ADDENDUM NO. 01

PROJECT: WCS – Hunt HS – Athletics Renovation

CPL PROJECT NO. R22.16900.00

DATE: 10.16.2023

3 COUNTERTOP & MASONRY OPNG DETAIL
A401 1 1/2" = 1'-0"

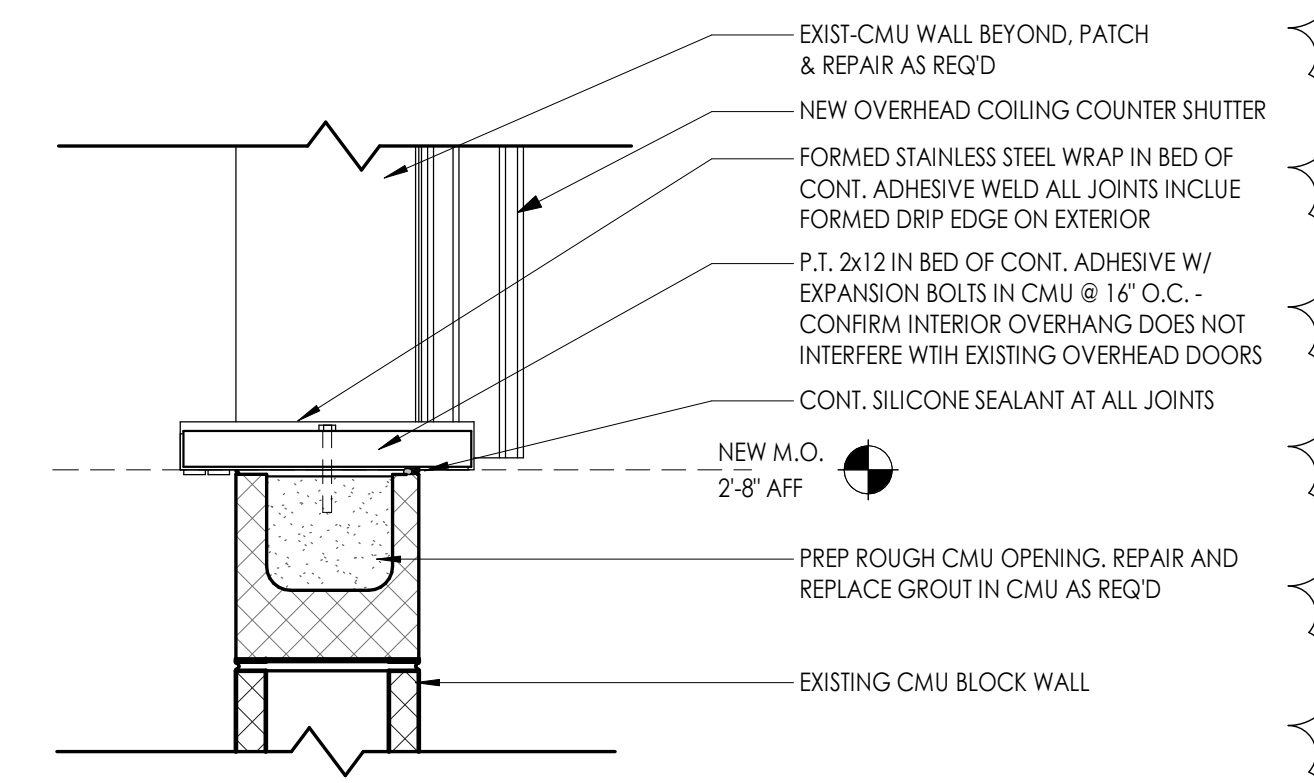
Provided detail of top of counter openings.

1 CONCESSIONS BUILDING ACCESSORY, EQUIPMENT, AND FINISH PLAN

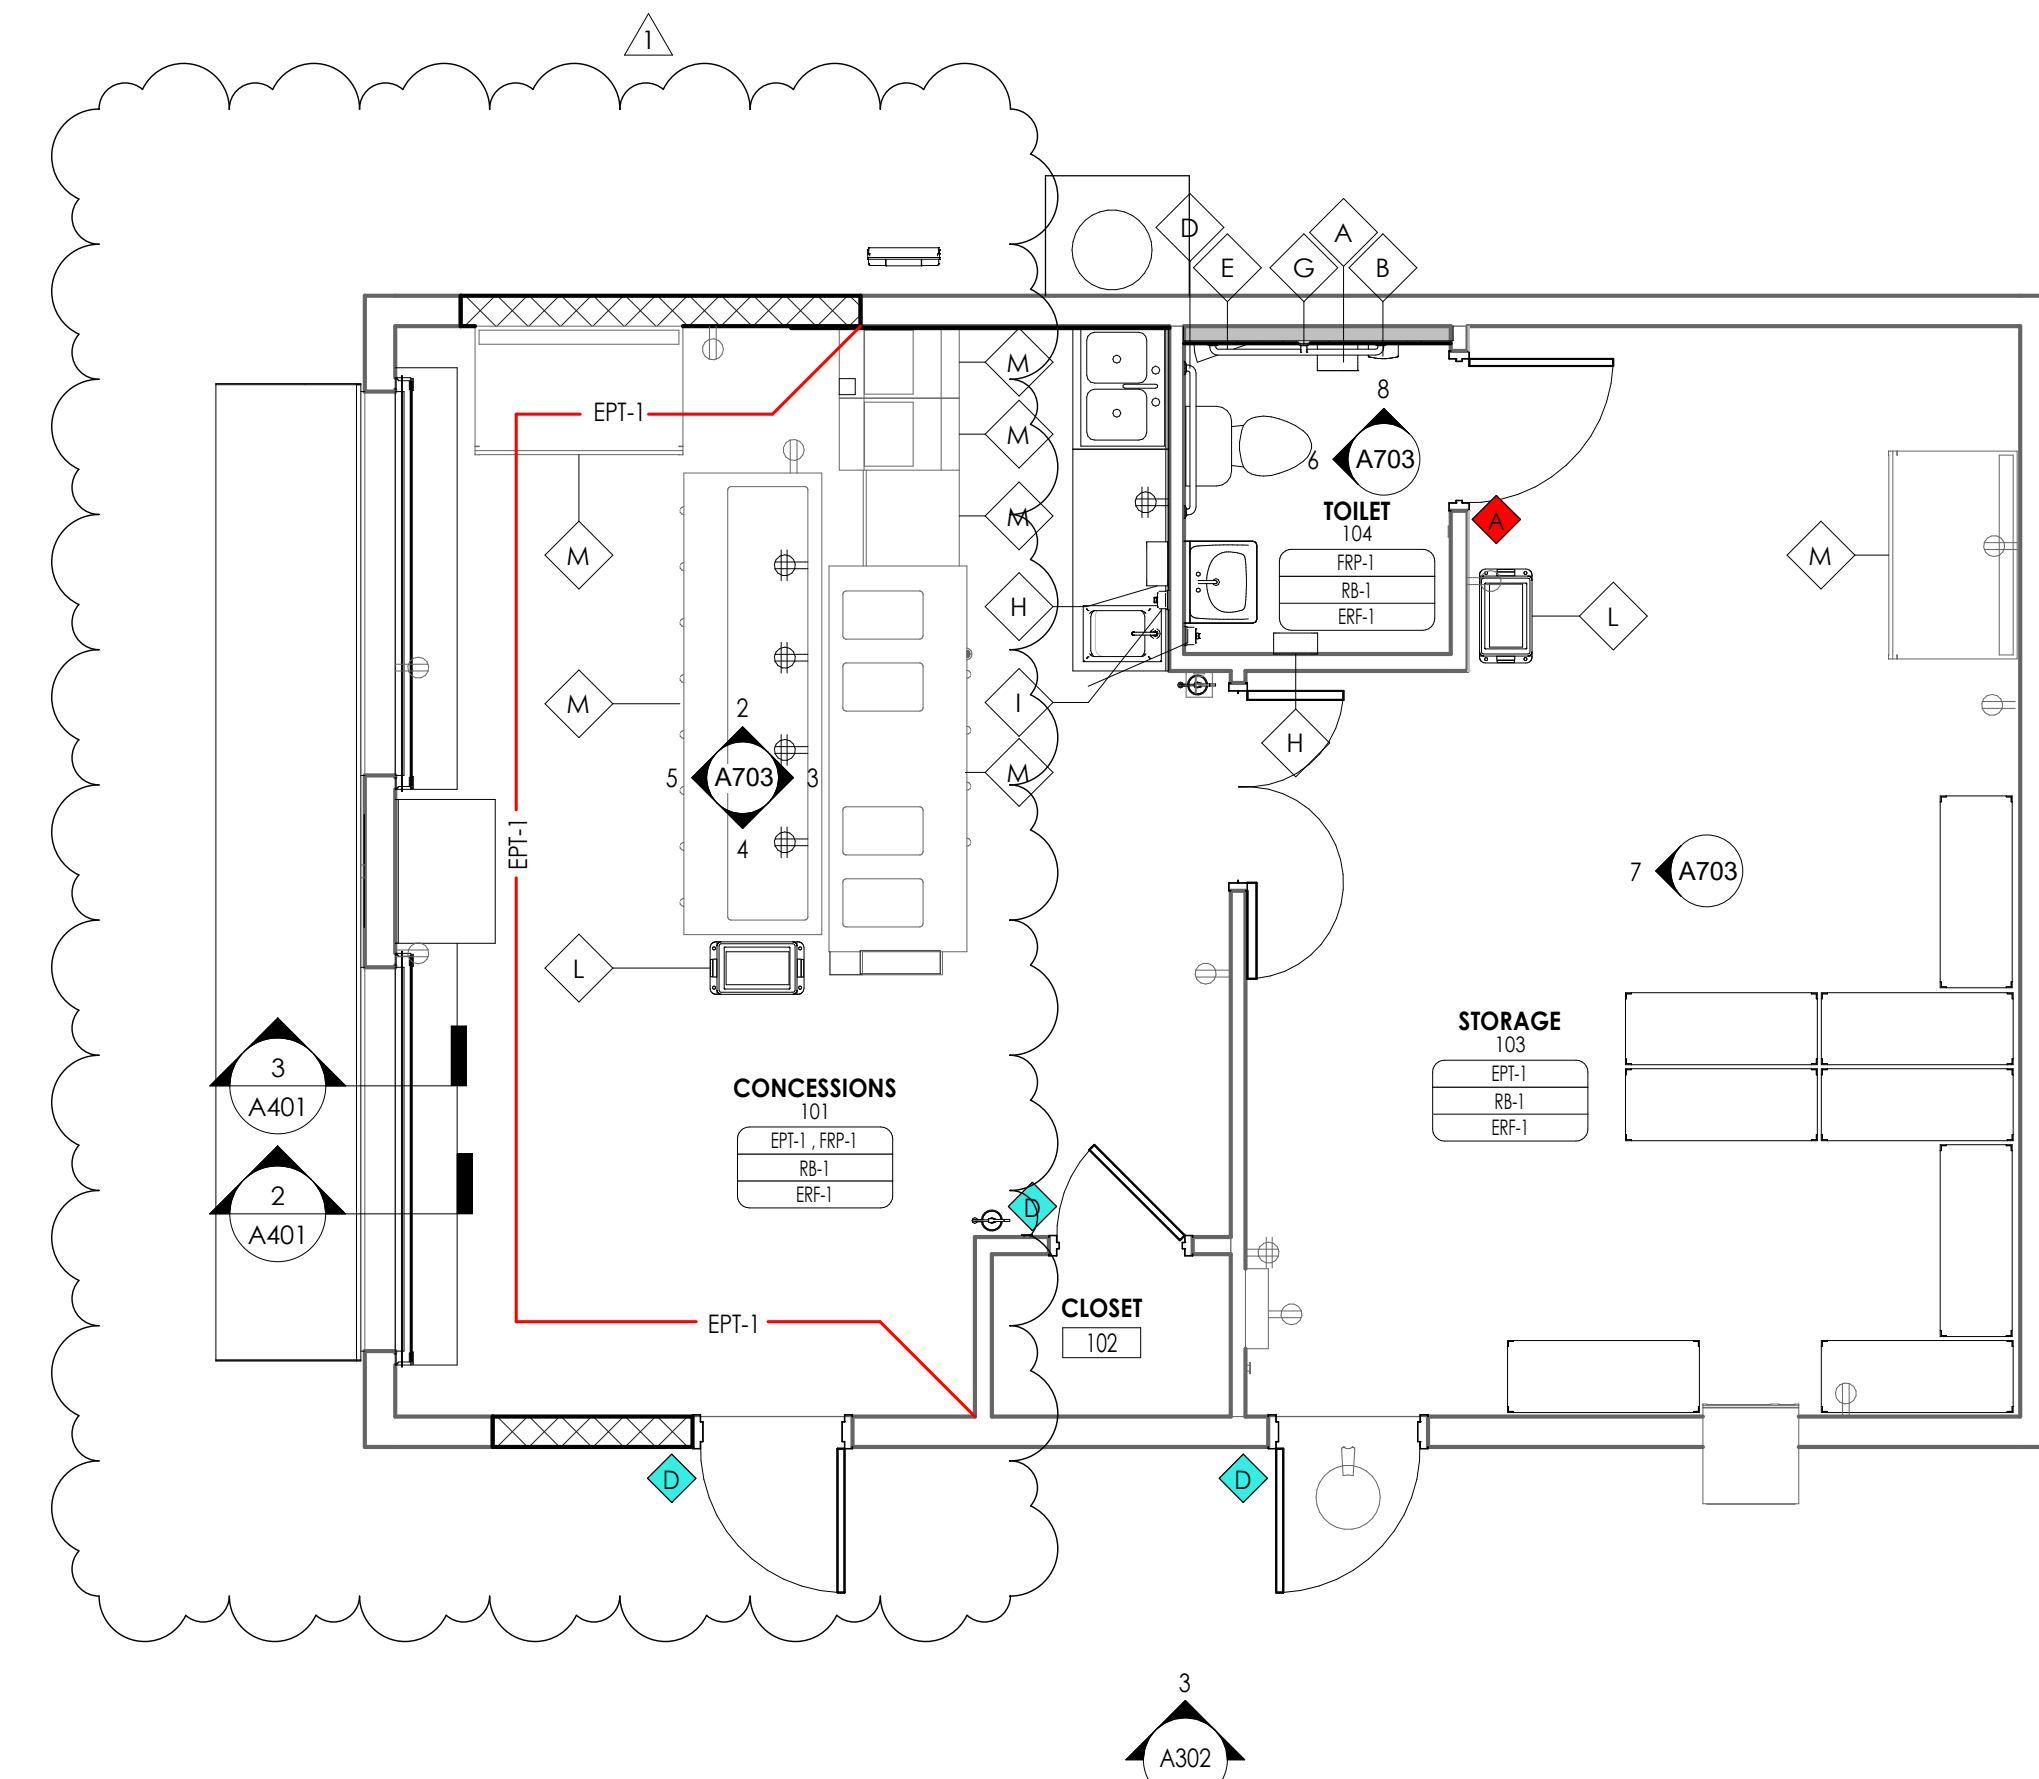
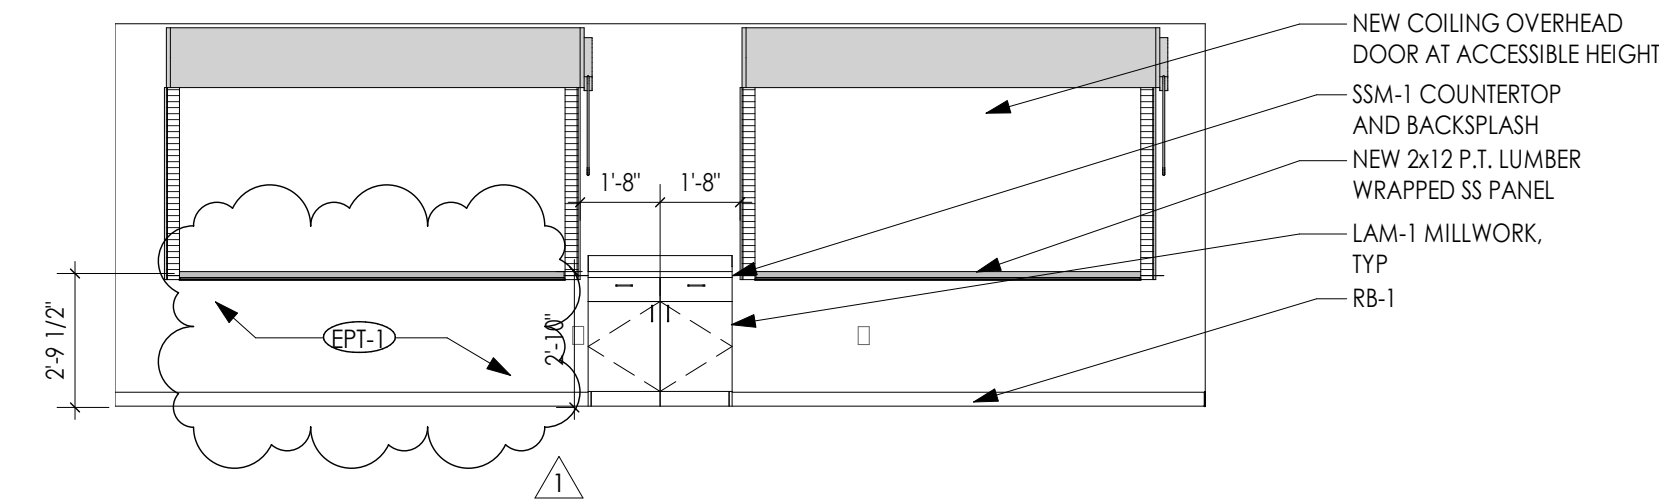
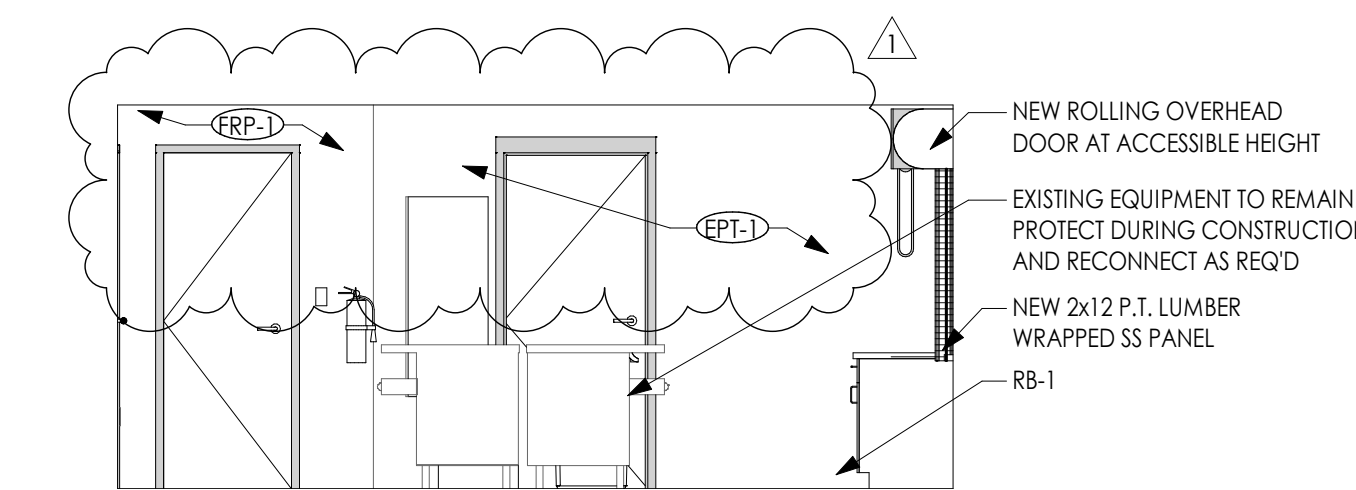
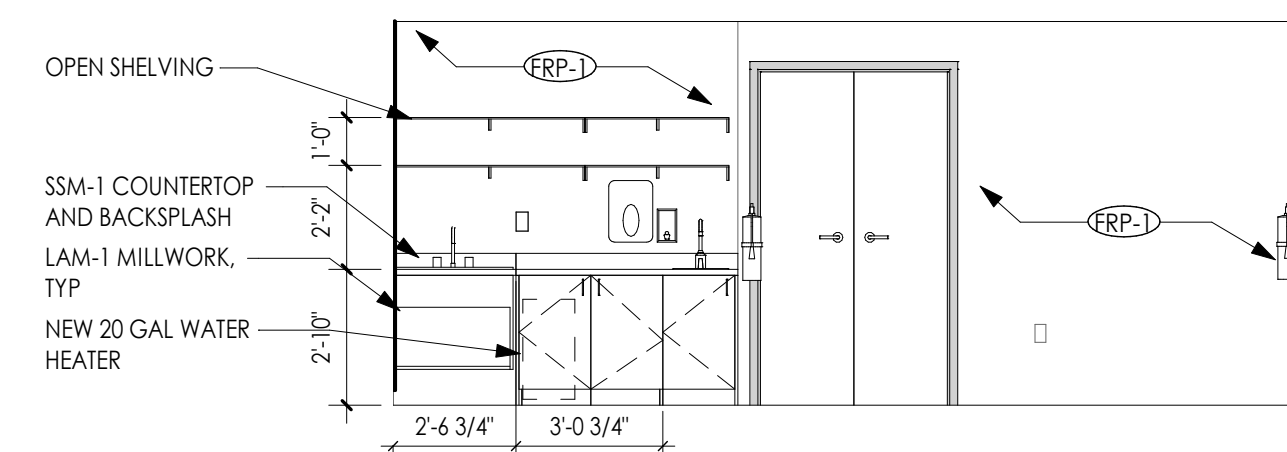
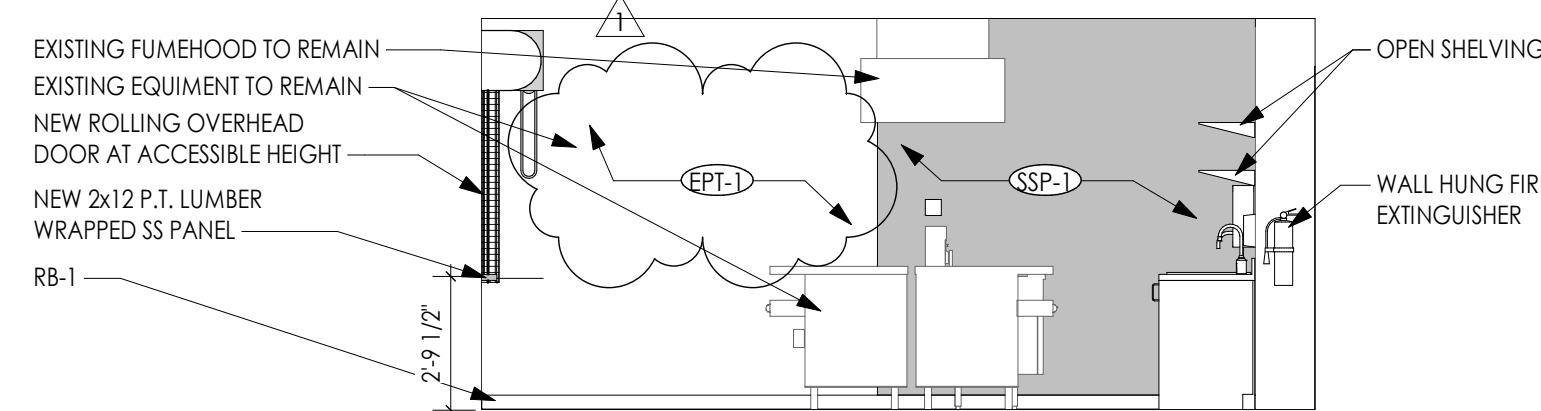
A703 – Concessions Building Accessory Floor plan and Interior Elevations

Updated to clarify wall finishes in Kitchen.
